February 26, 2015

ADDENDUM B

Saint James Catholic Church
Phase 1 Renovations and Additions
Kearney, Nebraska
RDG Project No. 2013.203.01, File 35.1

A4 SITE PLAN
1" = 20'-0"

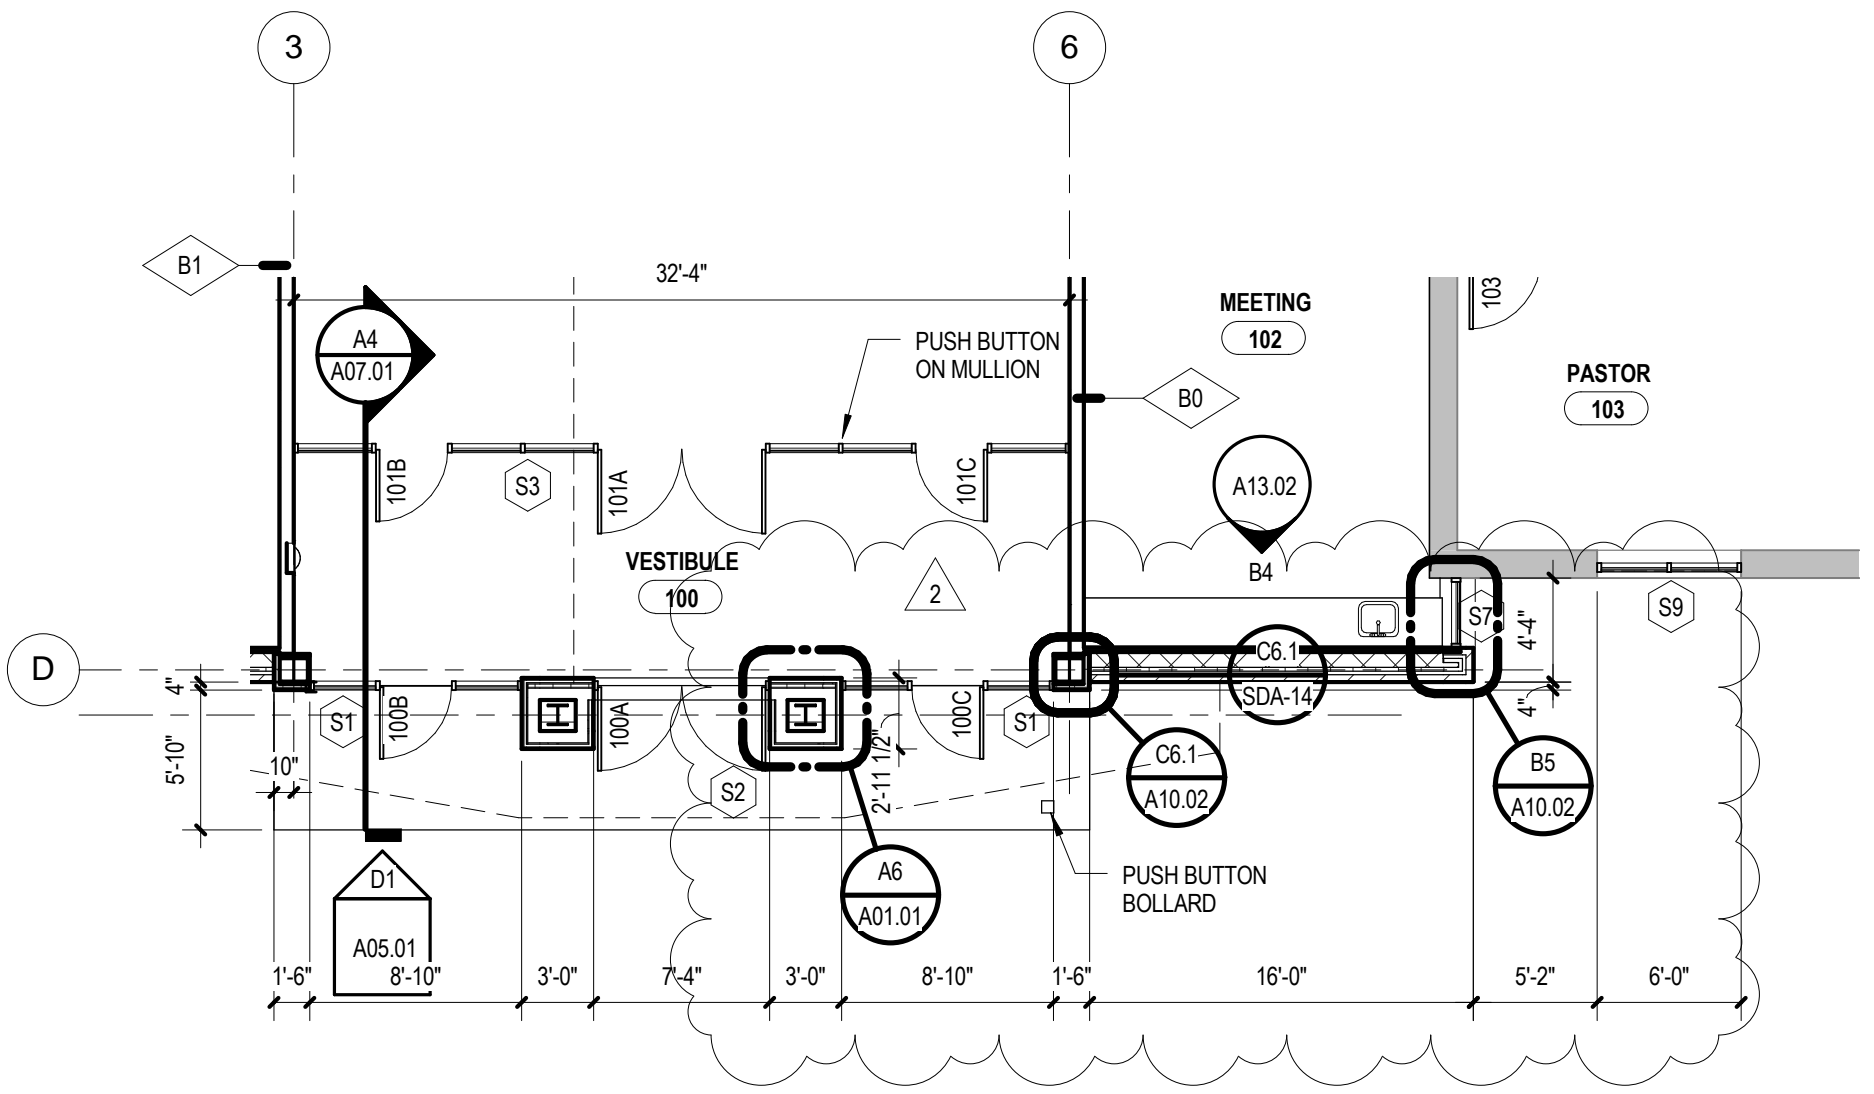
- A. Update drainage, sod, and paving notes per attached Supplemental Drawing SDA-04.
- B. Add the following General Notes:

A6 ALUM JAMB
3/4" = 1'-0"

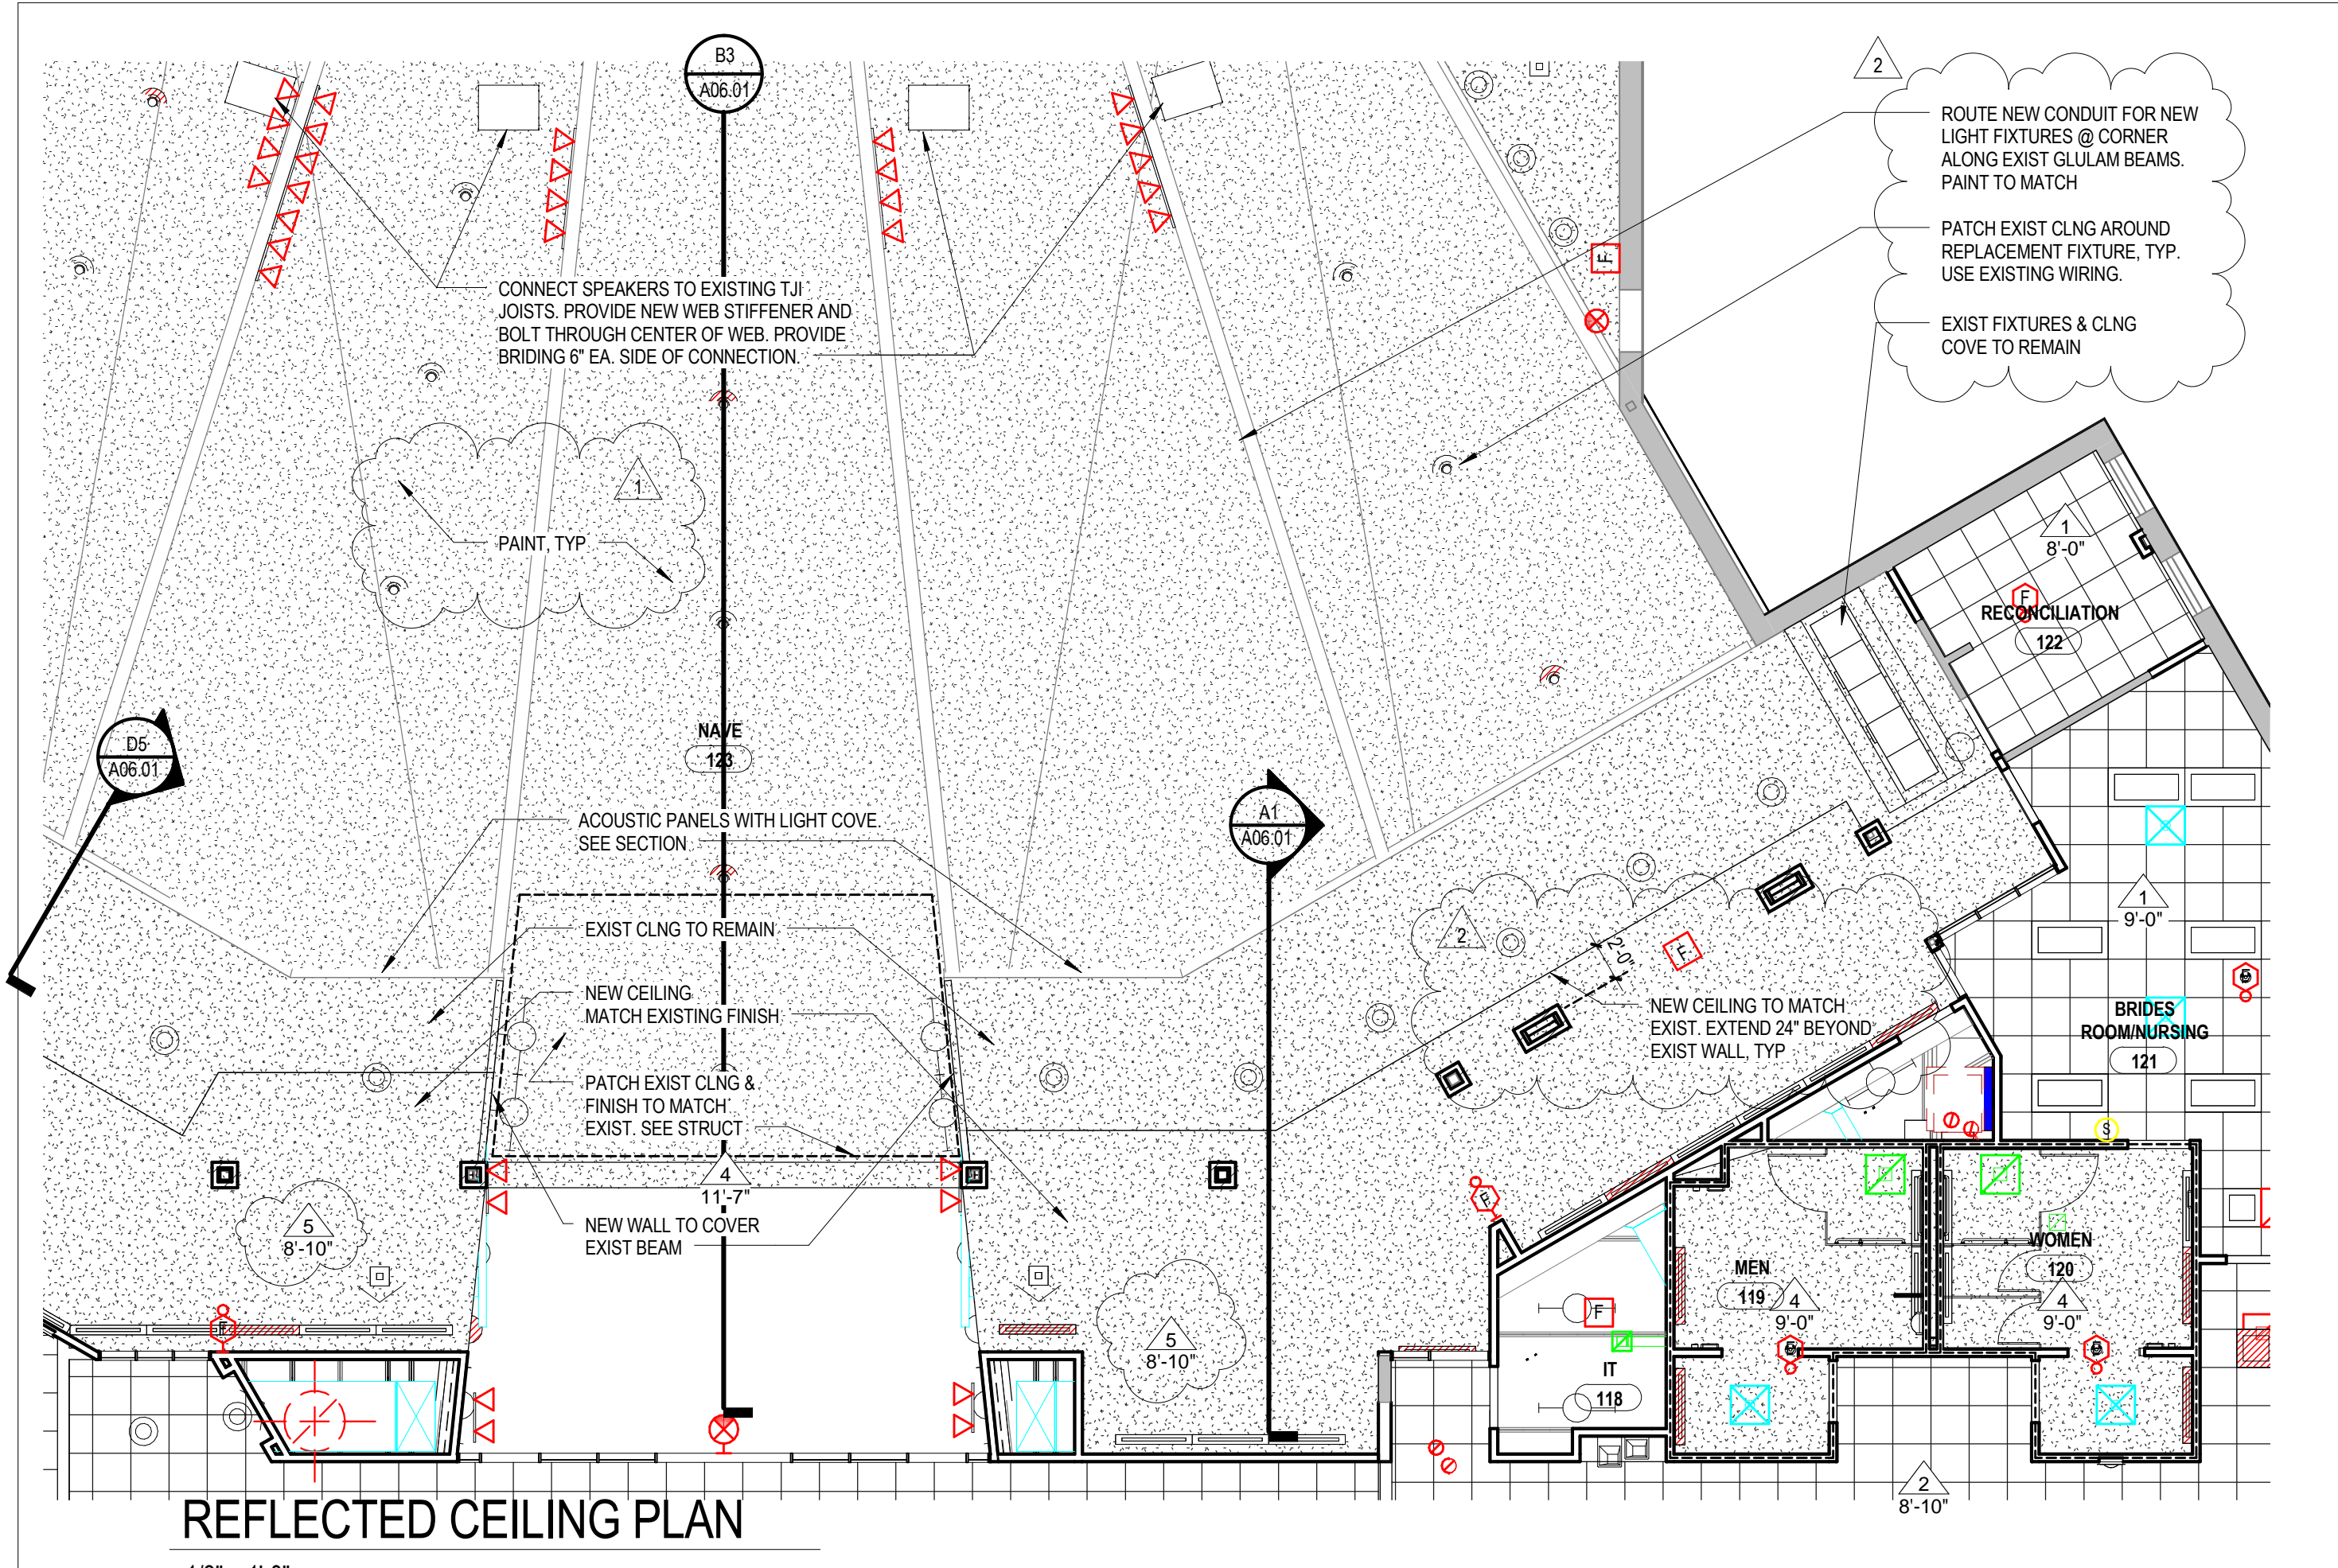
- A. Plan Notes:
 - 1. Note 3.8: Add the following sentence:
... Provide panel signs at Rooms 119, 120, and for Alternate 1: 131, 132, and 133.
 - 2. Add Note 3.9 as follows:
3.9 Provide four (4) fire extinguisher cabinets (FEC). See Sheet A12.01 for locations.
 - 3. Add Note 5.3 as follows:
5.3 Telecom equipment is furnished and installed by Owner. Coordinate with electrical work in documents.
- B. Floor Plan: Add detail callouts as indicated on Supplemental Drawing SDA-05.
- C. Plan A1, Add Alternate 1: At Nursery/Preschool (134), add note to the east wall casework reading:
84"H x 33"W x 24"D full-height plam wall cabinets w/ four adjustable shelves.
- D. Add Detail A6, Alum Jamb, per attached Supplemental Drawing SDA-05.

Project Number: 2013.203.01 | Date: 02/25/15 | Add to Sheet: A03.01 | Drawing: SDA-06

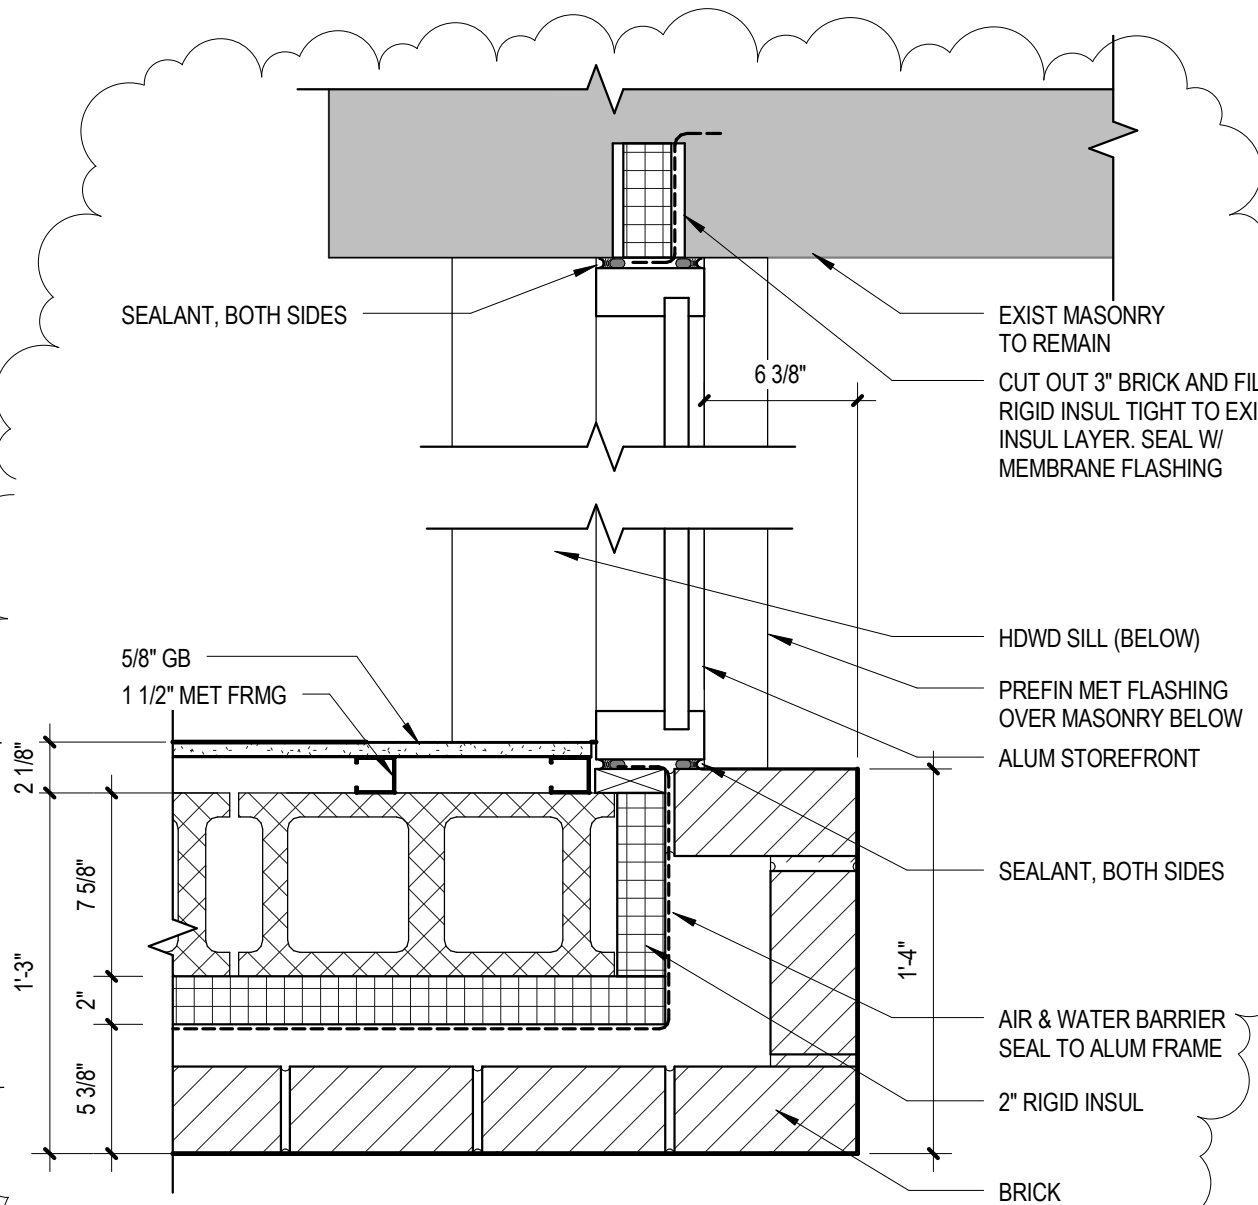
1. Update plan with notes for electrical conduit and ceiling patching per attached Supplemental Drawing SDA-06.
2. To the west of Corridor (126), revise the ceiling tag note reading Type 3 @ 7'-11" to read, ***"Type 3,@ 8'-0".***
3. At Women 131, add the following note:

ROUTE NEW CONDUIT FOR NEW LIGHT FIXTURES @ CORNER ALONG EXIST GLULAM BEAMS. PAINT TO MATCH

PATCH EXIST CLNG AROUND REPLACEMENT FIXTURE, TYP. USE EXISTING WIRING.

EXIST FIXTURES & CLNG COVE TO REMAIN

D4 WALL DETAIL
1 1/2" = 1'-0"

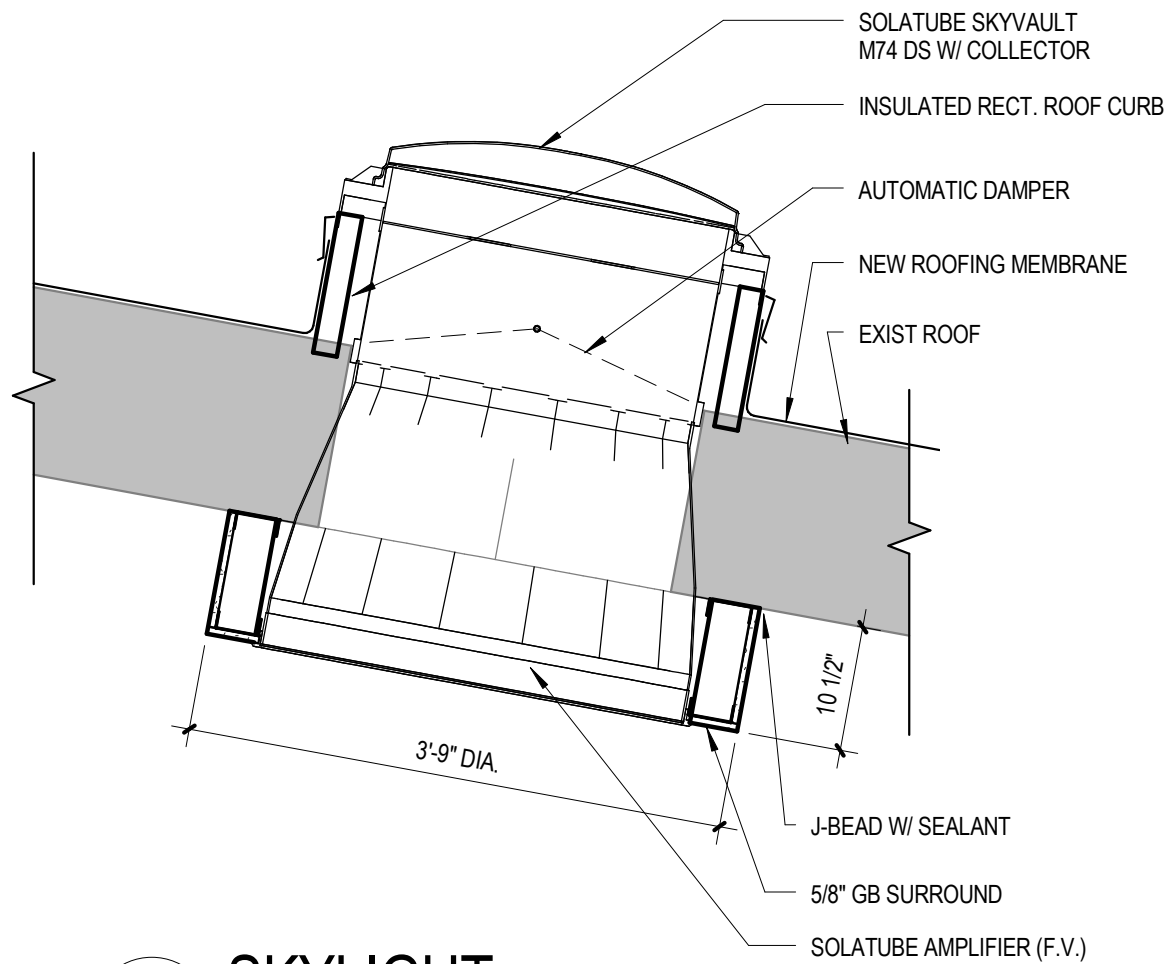
- A. Detail A1, Skylight: Revise detail per attached Supplemental Drawing SDA-09.
- B. Detail D4, Wall Detail: Revise detail per attached Supplemental Drawing SDA-09.
- C. Detail D5, Wall Detail: Revise detail per attached Supplemental Drawing SDA-12.

COVE DETAIL

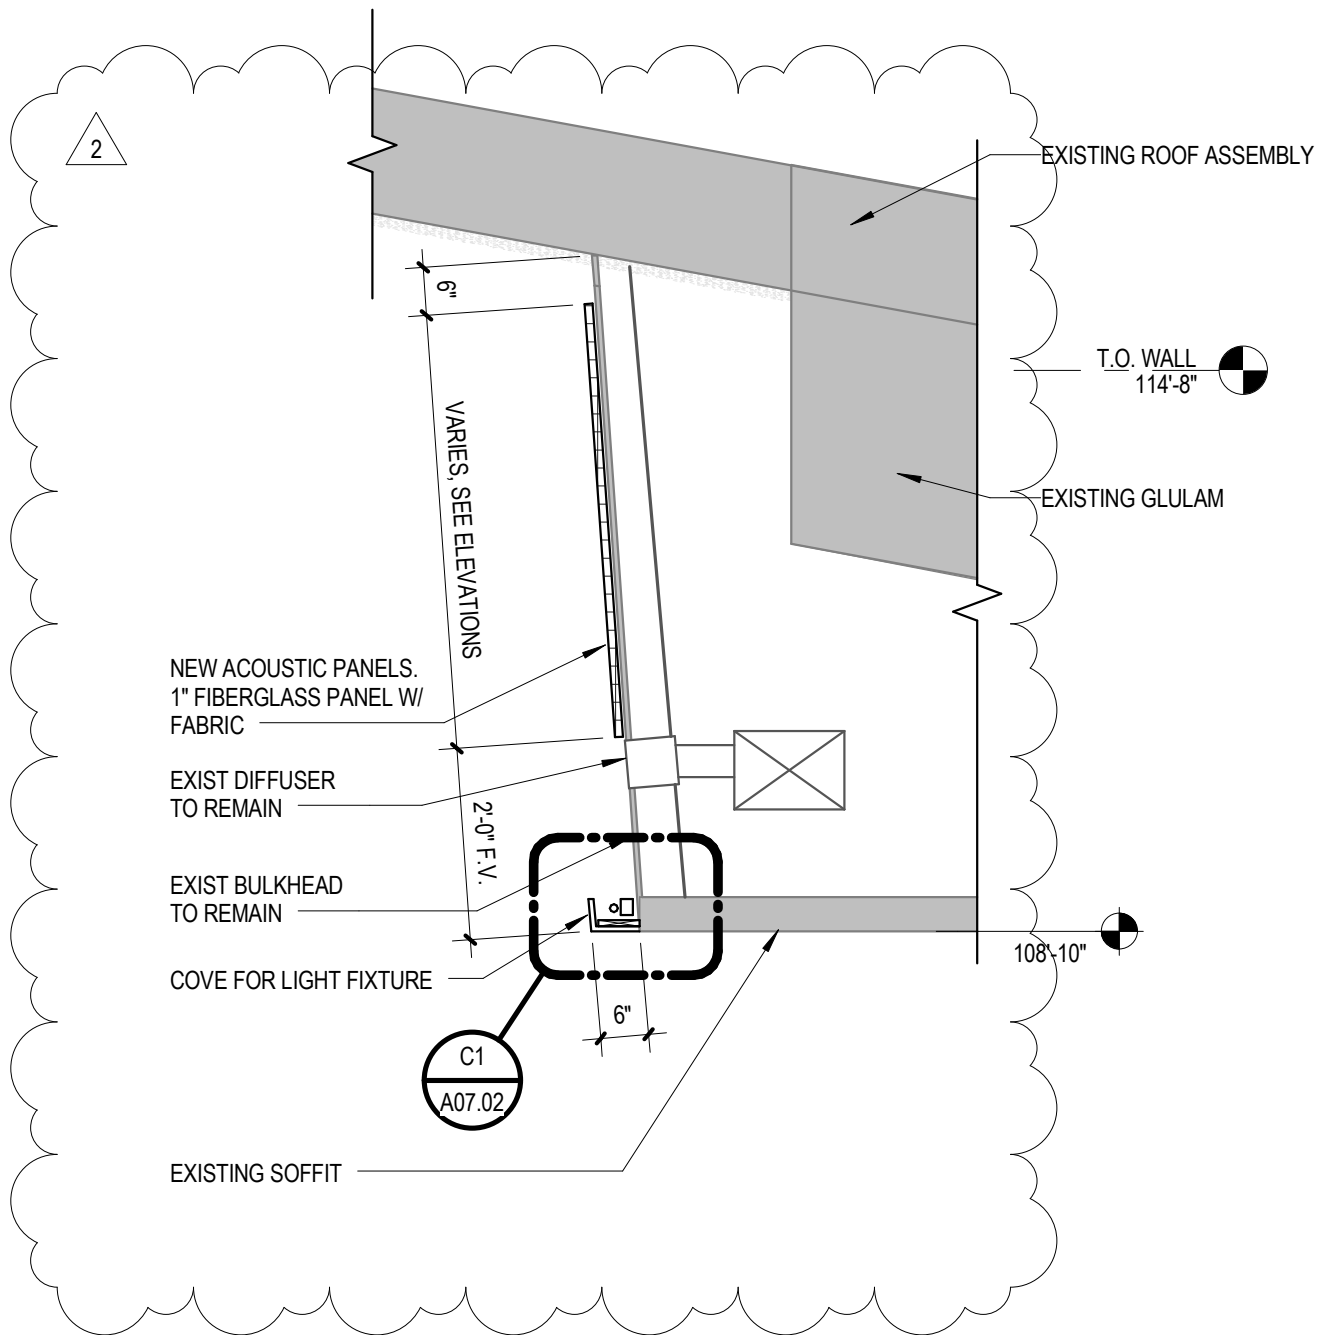
- A. Add Detail C1, Cove Detail, per attached Supplemental Drawing SDA-10.
- B. Detail C2, Wall Section:
 - 1. Add reference at window sill reading, **“C3 / A10.02.”**
 - 2. Add note to exterior wall reading, **“5/8” Exterior Plywood.”**
 - 3. Add note to bottom soffit, below note reading “3 4/8” Metal Stud” that reads **“5/8” GB.”**
- C. Detail B5, Wall Section: Revise per attached Supplemental Drawing SDA-11.
- D. Detail D4, Wall Detail: Update coping with insulation, water and air barrier, and blocking per attached Supplemental Drawing SDA-13.
